## Product Change Notification

**1. ECR #:** 24-12564-1  
**Notification #:** 747

**3. Series:**  
• EBCM - EXAMAX BACKPLANE CABLE

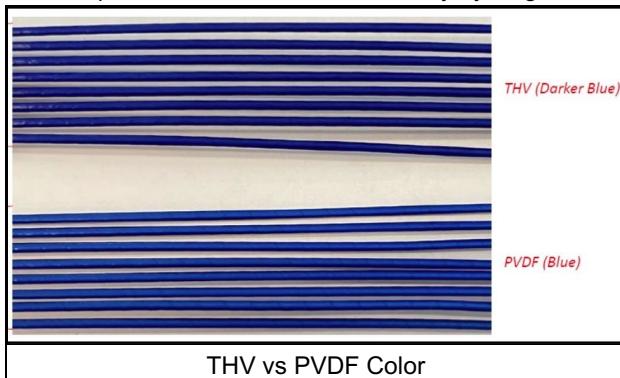
Revised product will use cables with PVDF jacket material instead of THV material. This will be a rolling change as existing THV inventory is depleted.

Revised product can be identified visually by a lighter shade of blue.

Samtec has been informed by our 3rd party supplier of THV that THV is going End of Life and no longer supported. Samtec analyzed alternative materials and has selected and qualified PVDF as an approved alternative.

- Form - No dimensional changes, weight change from 1.723 to 1.673 lb /1000ft\*, color change as described in Section IV. Method of Identifying Change
